Access Compliance Report Public Rights-of-Way (Pedestrian Signals)

Main Street: **IRVINE_BLVD** Cross Street: **CHARLOMA_DR** Location: **NE**

ADA ID: **SGAT211027110640** Signal Type: **One Push Button-APS** Overall Compliance: **No** Severity Scores: **BTN 1: 25** **BTN 2: N/A** **No BTN: N/A**

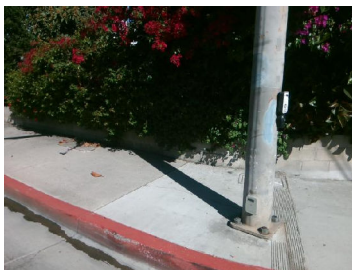
OC Std/PROW: **R404.2, R404.3**

Possible Solutions: Remove and Replace Clear Space.
